# Access Compliance Report

## Public Rights-of-Way

### (Curb Ramps)

Intersection ID: 51704	Main Street: IKEA_BV	Cross Street: BROOKSIDE_LN	Location: W
ADA ID: 0462A0AE08E3	Ramp Type: Perp	Initial Pass/Fail: Fail	Overall Compliance: No
		Severity Score: 12.5

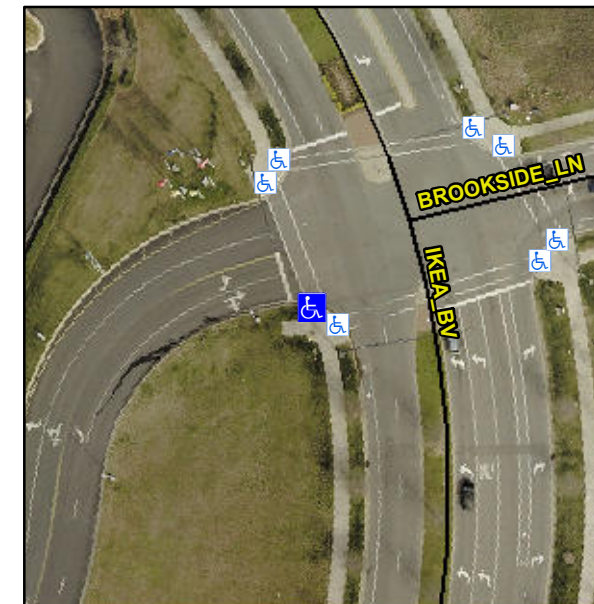
**Not Found, R304.5.3**

Compliance	Description	Data	Compliance	Description	Data
N/A	Ramp Length (in)	94.0	Yes	Ramp Slope (%)	6.3
Yes	Ramp Width (in)	48.0	No	Ramp XSlope (%)	5.1
N/A	Flare Type LT	N/A	N/A	Flare Type RT	N/A
N/A	Flare Slope LT (%)	N/A	N/A	Flare Slope RT (%)	N/A
N/A	Flare Traversable LT?	N/A	N/A	Flare Traversable RT?	N/A
N/A	Landing Length (in)	N/A	N/A	DWS Provided?	N/A
N/A	Landing Width (in)	N/A	N/A	DWS Contrast?	N/A
N/A	Landing Slope (%)	N/A	N/A	DWS Length (in)	N/A
N/A	Landing X Slope (%)	N/A	N/A	DWS Full Width?	N/A
N/A	Landing Curb? (Y/N)	N/A	N/A	DWS Offset (in)	N/A
N/A	Shared Landing?	N/A			
N/A	Gutter Ponding?	N/A	N/A	Gutter Slope (%)	N/A
N/A	Gutter Lip Ht (in)	N/A	N/A	Gutter X Slope (%)	N/A
N/A	Painted X Walk1?	Yes	N/A	Painted X Walk2?	N/A
	X Walk 1 Direction	To N		X Walk 2 Direction	N/A
N/A	X Walk 1 Width (in)	96.0	N/A	X Walk 2 Width (in)	N/A
	X Walk 1 Slope (%)	1.2		X Walk 2 Slope (%)	N/A
	X Walk 1 X Slope (%)	2.3		X Walk 2 X Slope (%)	N/A

**Remove & Replace Entire Ramp.**
